METROPOLITAN GOVERNMENT OF NASHVILLE AND DAVIDSON COUNTY

STAFF RECOMMENDATION
110 South 17th Street
November 20, 2013

Application: New construction-addition
District: Lockeland Springs-East End Neighborhood Conservation Zoning Overlay
Council District: 06
Map and Parcel Number: 08310021900
Applicant: David Baird, Building Ideas
Project Lead: Paul Hoffman, paul.hoffman@nashville.gov

ROOF PLAN

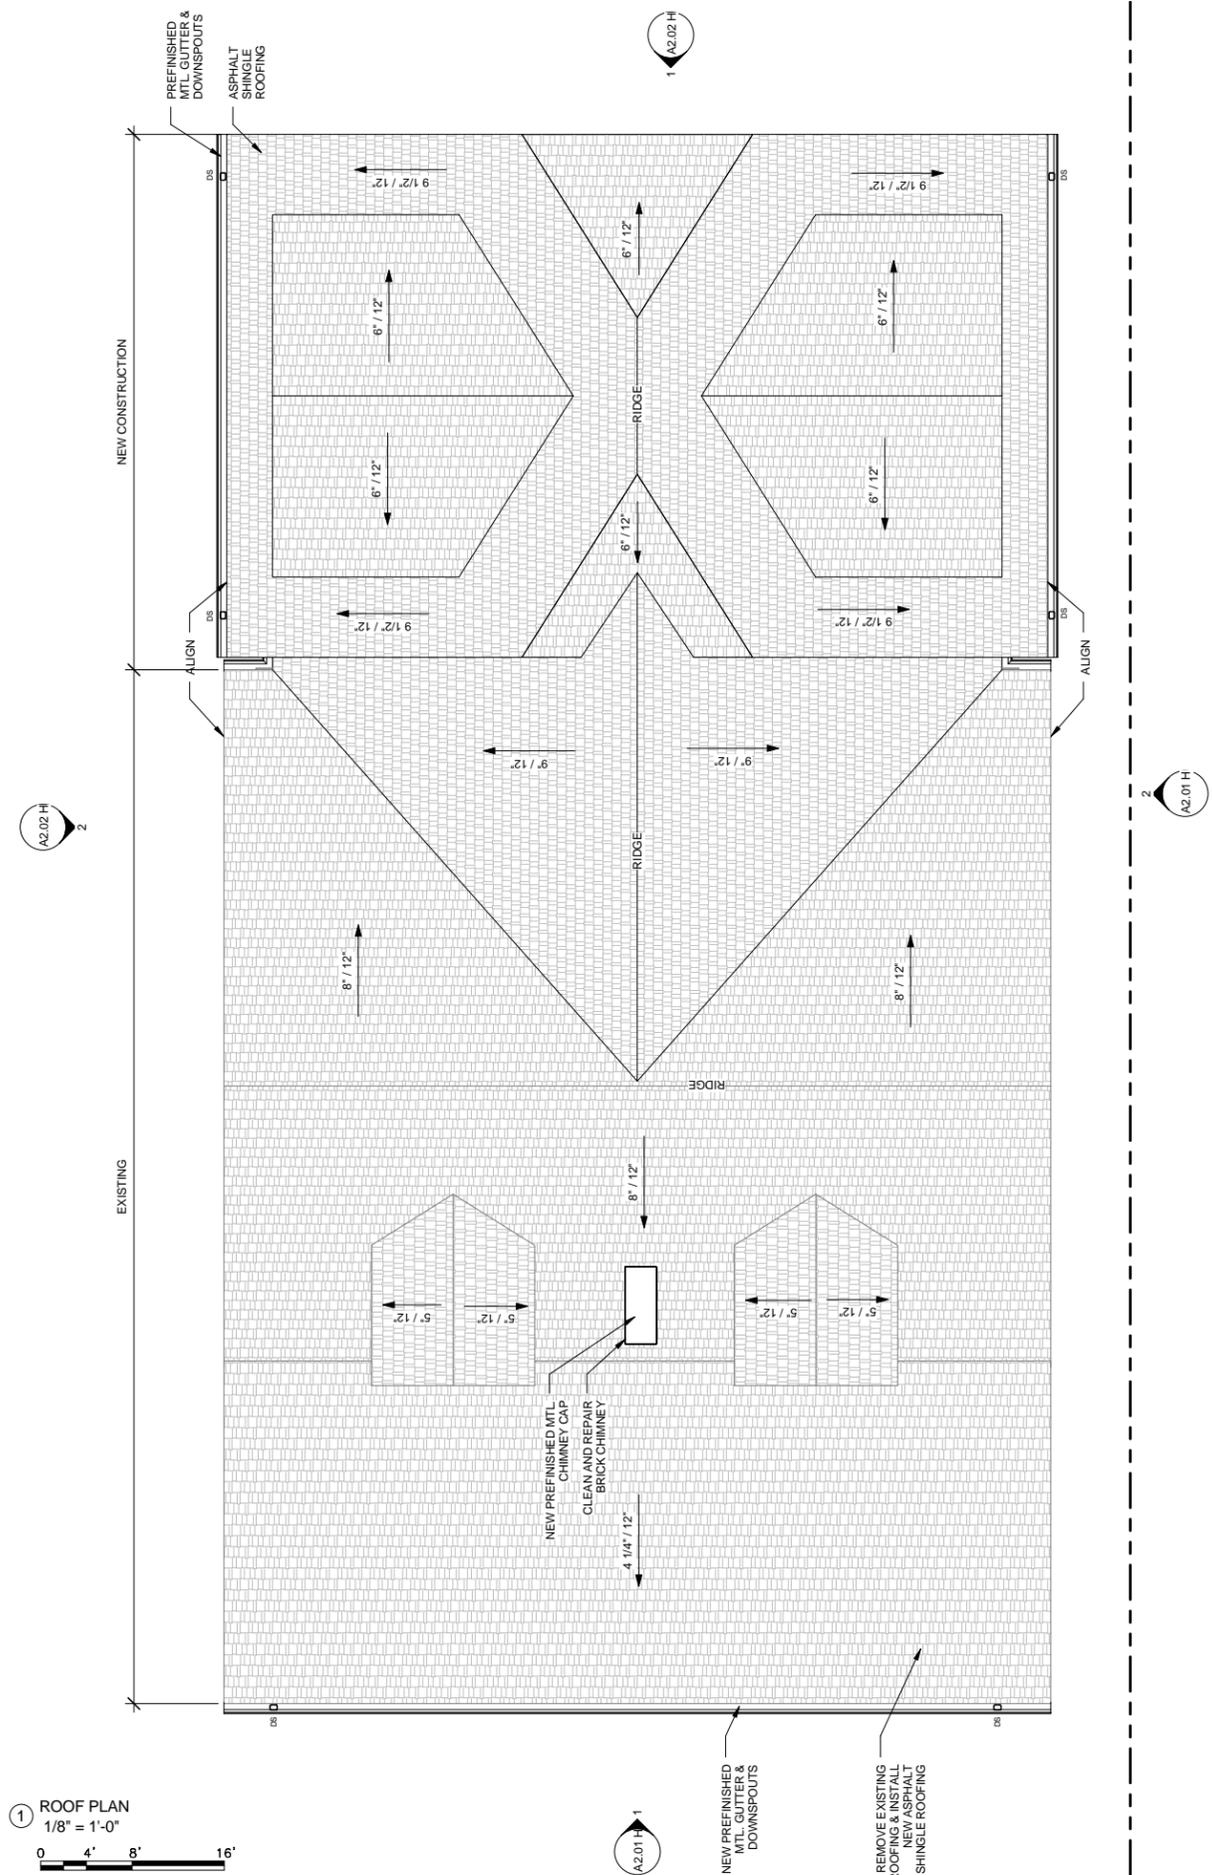
The addition's roof is clipped front to back at a pitch of 9/12 with gabled dormers to each side. It is joined to the existing roof by one of the same pitch. The dormers are pitched 6/12. The brick chimney centered on the front roof will be cleaned and repaired as necessary, and will receive a new metal cap. The project meets section II.B.5.

BUILDING ELEVATIONS

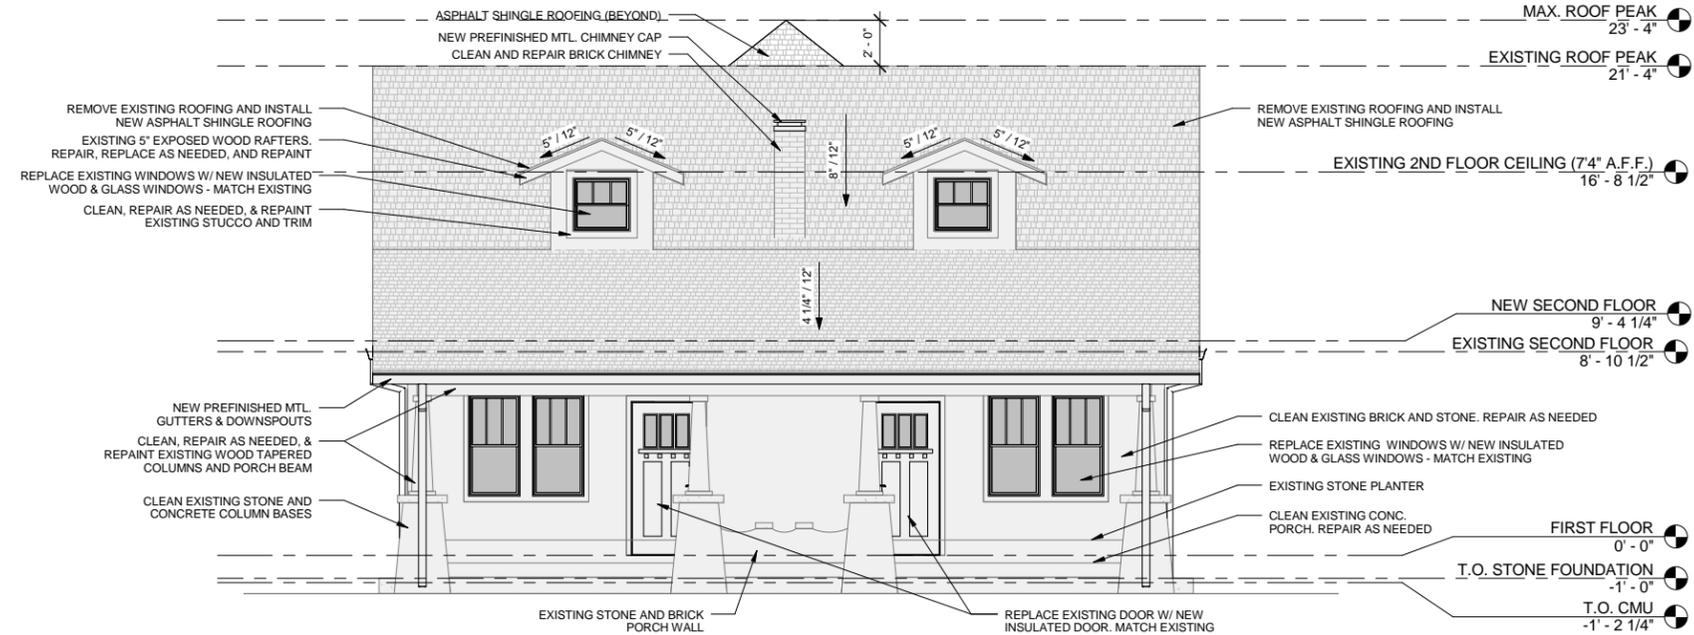
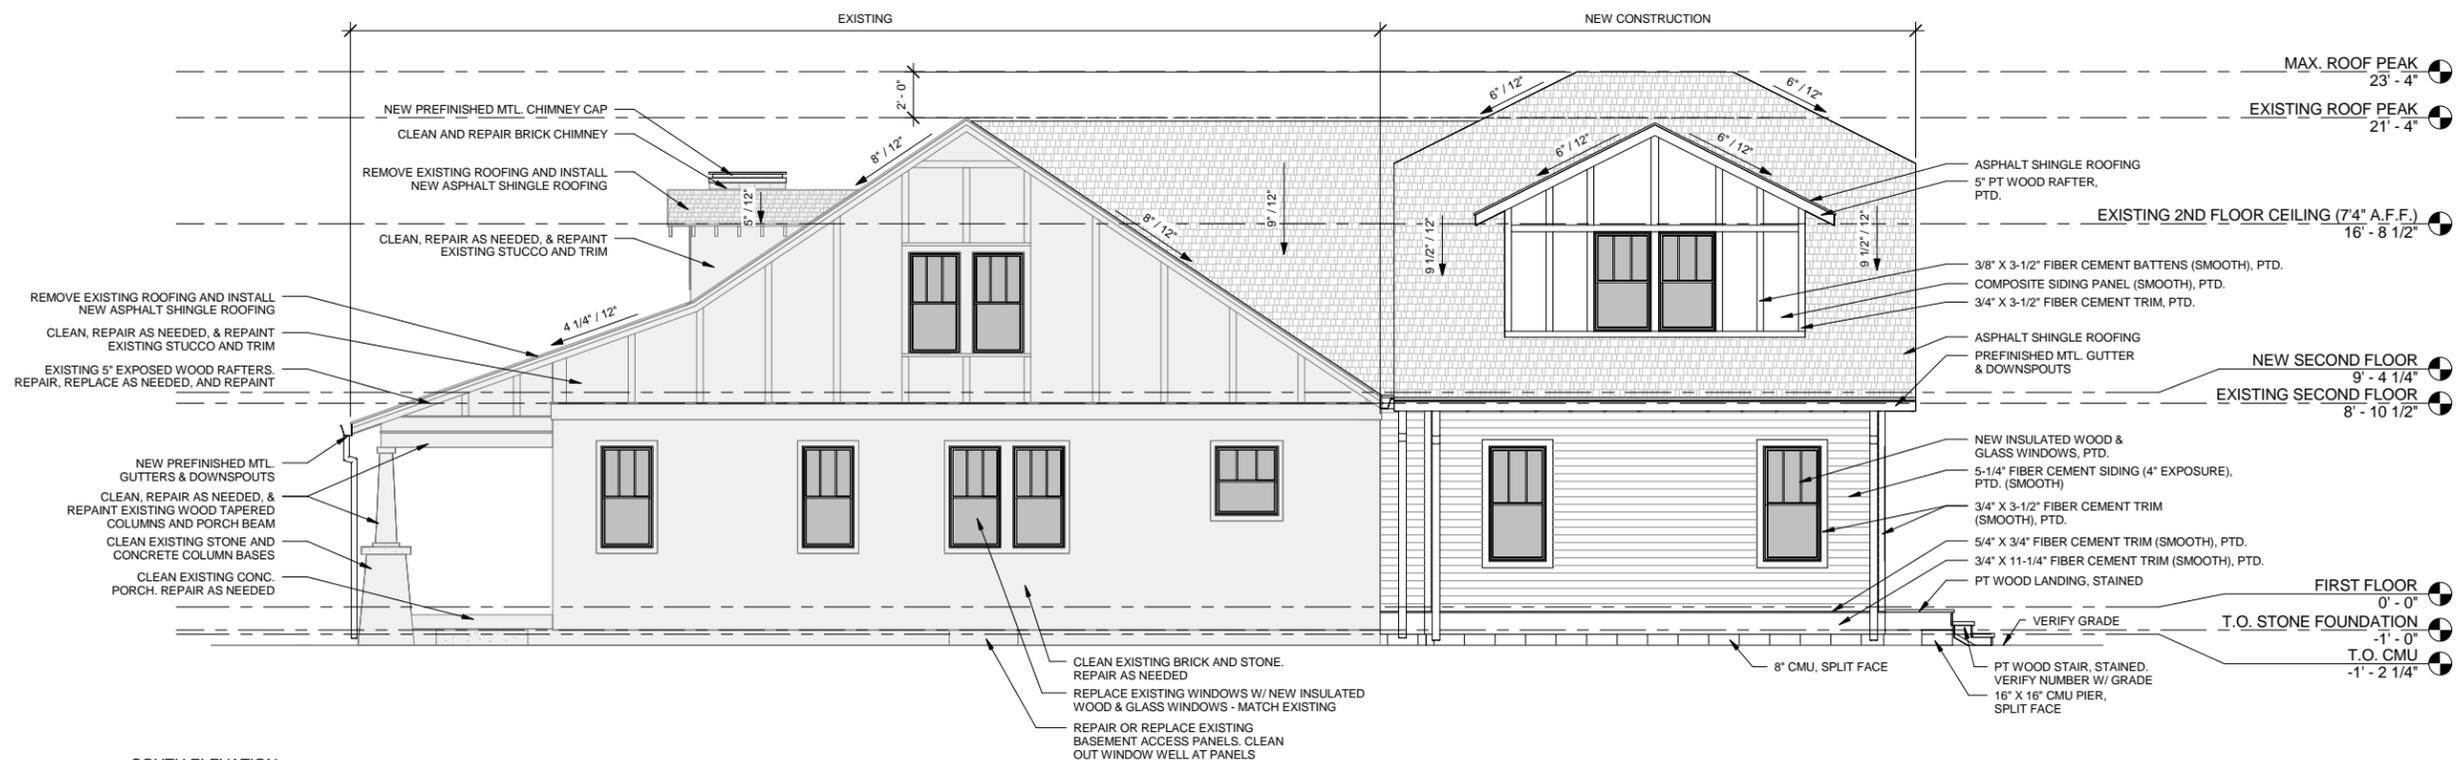
The proposed addition is one and a half stories. It reaches a height of twenty- three feet and four inches (23'4") which is two feet (2') taller than the ridge of the existing house. The new roof is clipped, and its maximum height begins forty-four feet (44') back from the front of the house. Because the additional height is minimal and does not take place until far back on the lot and because the additional height will be roofing material, the addition will be minimally visible from the street and will not disrupt the original character of the house. The addition sets in two feet (2') on the side for two feet (2') before it bumps back out to the same width as the house.

The foundation and eave heights of the addition match those of the existing house.

GARAGE PLANS

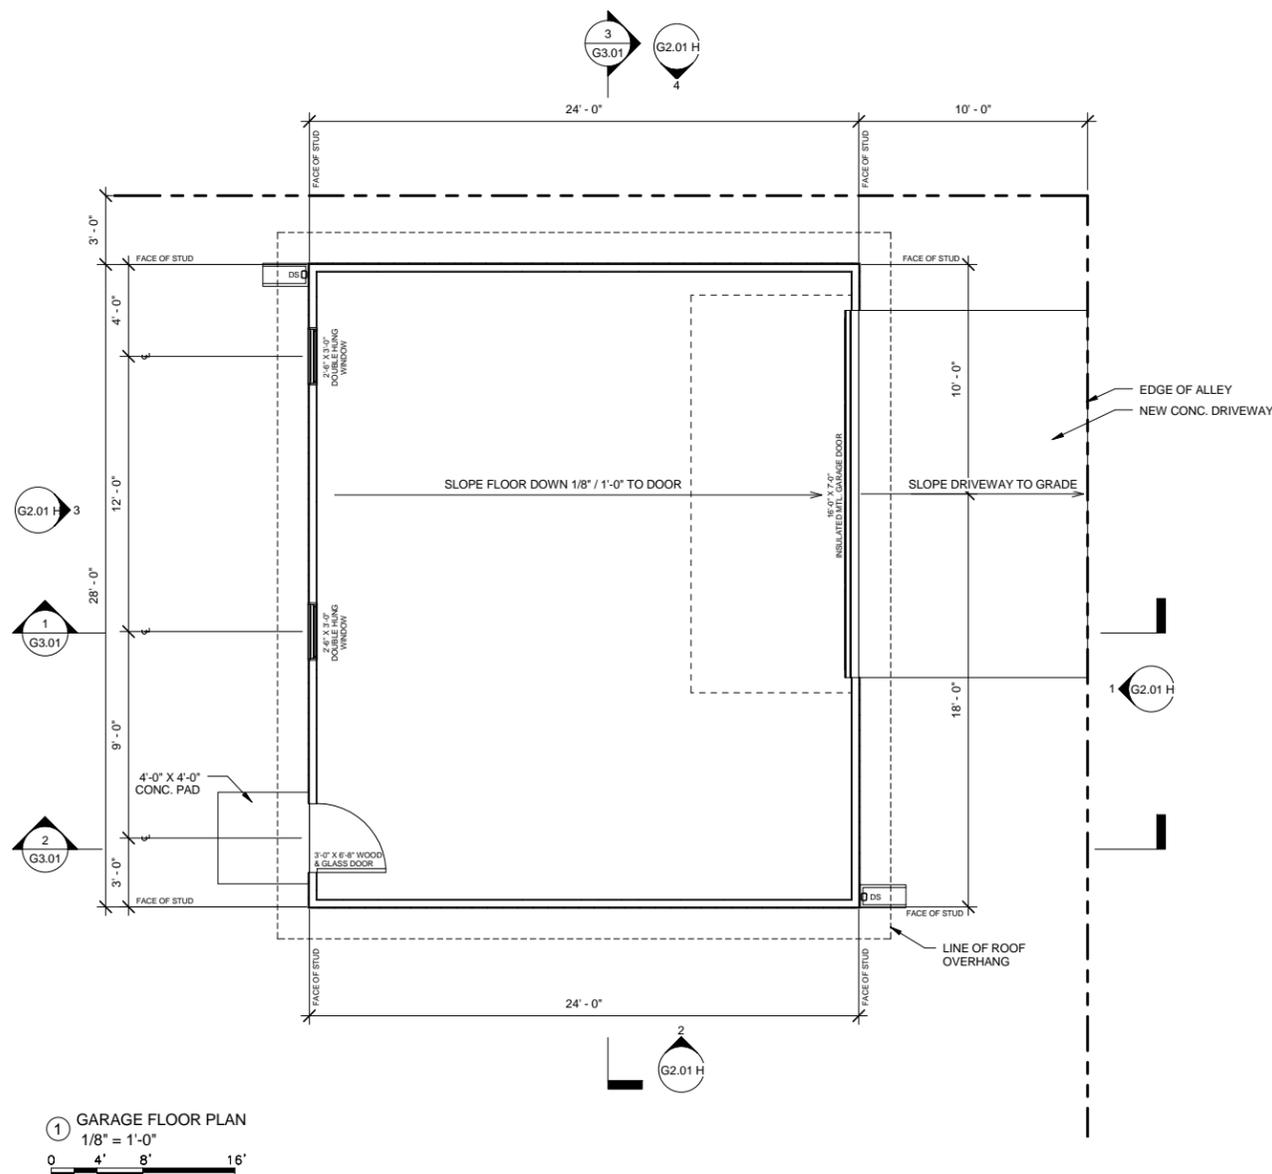
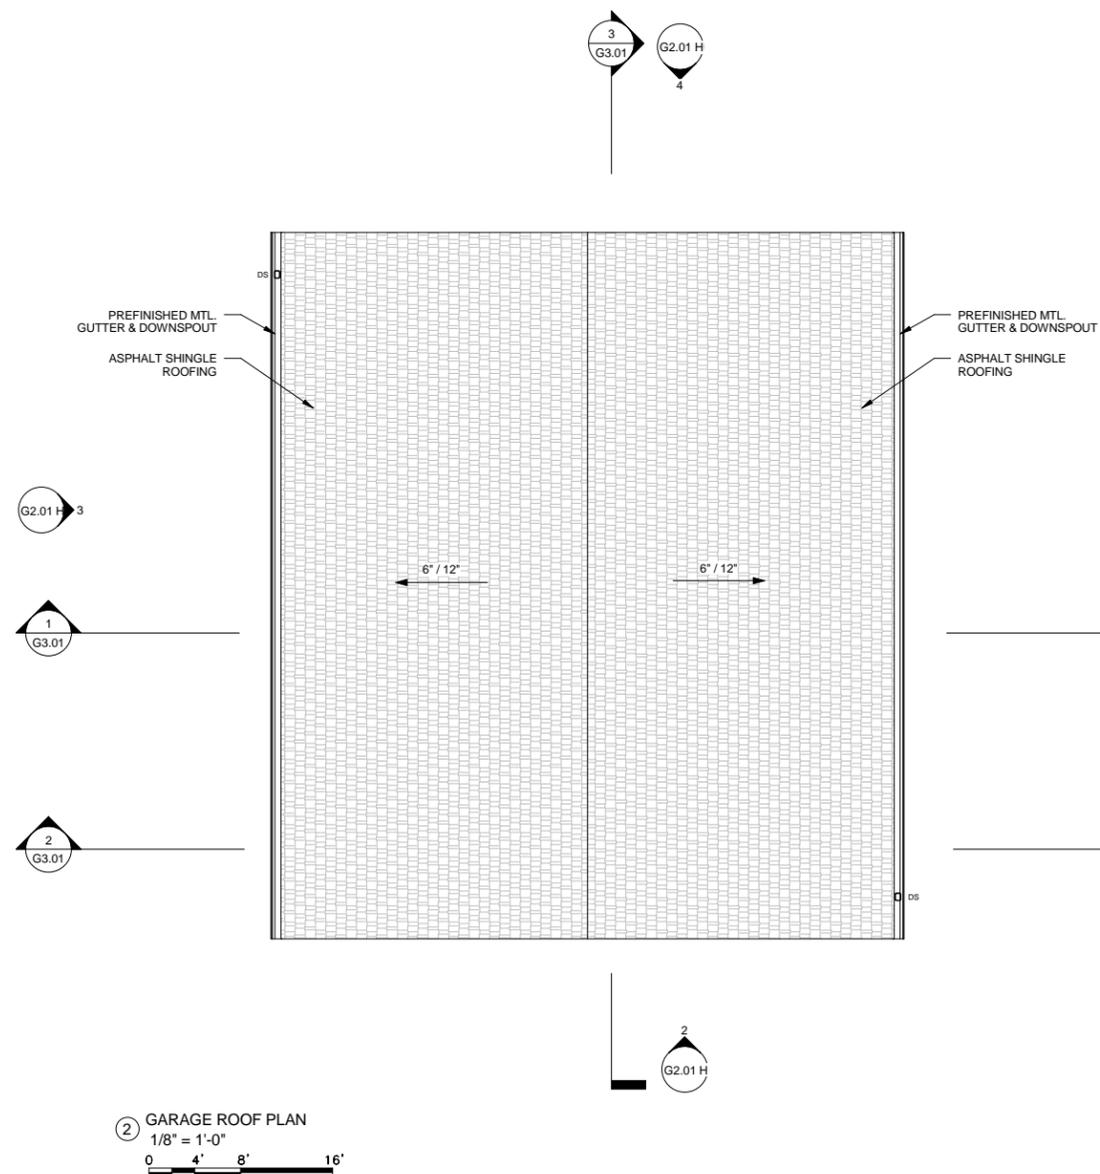
The proposed garage is a single story, fifteen foot (15') tall from grade building with a footprint of six hundred and seventy-two square feet (672 sq. ft.) and a side-facing gabled roof with 6/12 pitch. Compared to the twenty-three foot (23') height of the house, the building is subordinate to the primary dwelling. The eaves are nine feet (9') tall from grade. Materials are the same as those to be used on the addition. Its design is compatible with the existing house, its location is consistent with the neighborhood context, and it is not disruptive to the character of surrounding buildings. The project meets section II.B.8 of the design guidelines.
